REMARKS/ARGUMENTS

This Amendment is responsive to the Office action dated February 23, 2005, setting forth a shortened three month statutory period for reply expiring on May 23, 2005. A petition for a three month extension of time and associated fee are filed herewith, extending the period for response up to and including August 23, 2005.

Appl. No. 10/796,859
Amendment dated August 23, 2005
Reply to Office Action of February 23, 2005

FIG. 1

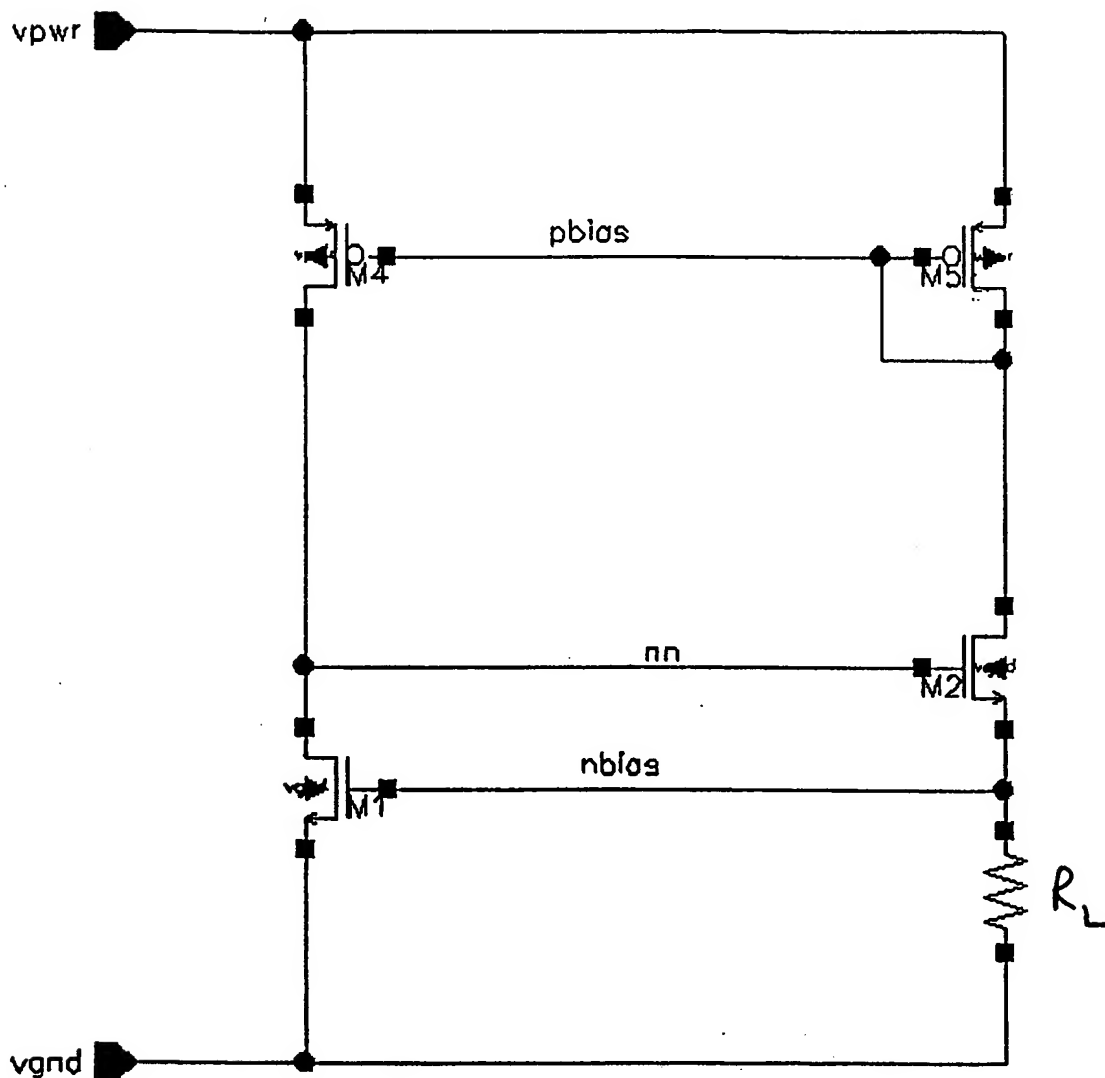
The Examiner required that Fig. 1 be designated with a legend "prior art." Fig. 1 has been labeled "PRIOR ART" on a replacement sheet that is attached hereto. Accordingly, this objection to the drawing should be withdrawn.

The attached sheet of drawings includes changes to Fig. 1. This sheet, which includes Fig. 1, replaces the original sheet including Fig. 1. In Fig. 1, the legend "PRIOR ART" has been added.

PRIOR ART
LEGEND
ADDED

PRIOR ART
